# COP8SBR9/SCR9/SDR9 User Information Sheet Rev. E

This user information sheet is intended to aid users of the COP8SBR9/SCR9/SDR9 series of products by documenting known problems and limitations of the C revision of this device and of product documentation for the device.

**Name:** **High Speed Timer/Port L Interaction**

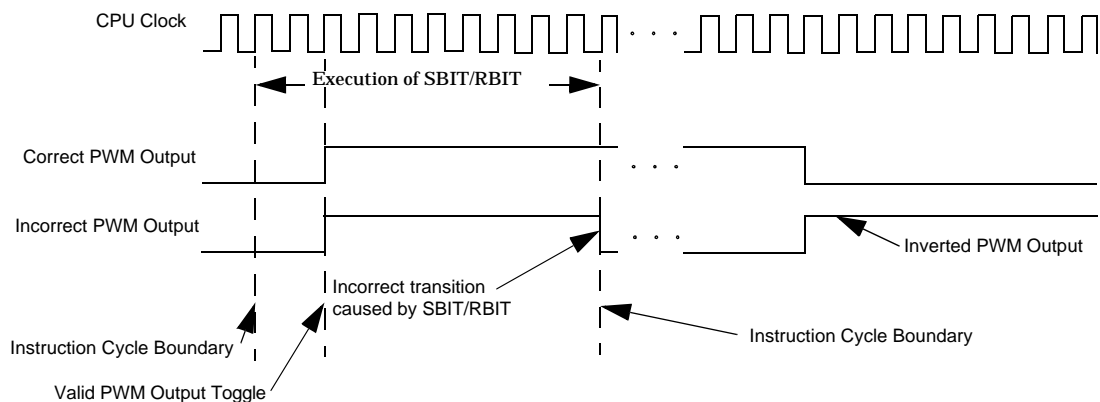
Description: If either Timer T2 or T3 is used in High Speed PWM mode and an SBIT or RBIT instruction operates on any other bit of the PORT L Data Register, the PWM output may **appear** to miss a toggle and thus be inverted. If the timer causes the PWM output to toggle in the middle of an SBIT or RBIT operation on the PORTLD Register, the PWM output may be set back to its state before the output toggle by the operation of the SBIT/RBIT. This can have the effect of generating a shortened pulse (less than one instruction cycle in width) on the PWM output and inverting the PWM duty cycle.

If the PWM Timer is used in low speed mode or if the PWM output toggle is synchronous with the end of the instruction cycle, this problem is not seen.

The following figure illustrates the PWM output when the failure is seen.

The user should be aware of the state of Timers T2 and T3 before any SBIT or RBIT instructions are executed which operate on the PORTLD register. If the PWM output is close to toggling, the user should delay the SBIT or RBIT instruction.

The following program sequence works to delay the operation. The user may wish to experiment with other sequences to see which best fits the application and to make sure that the time between the completion of the tests and the modification of PORTLD is not too long. The sequence can easily be modified to work with Timer T3.

Plan: This will be corrected in the next revision of the device.
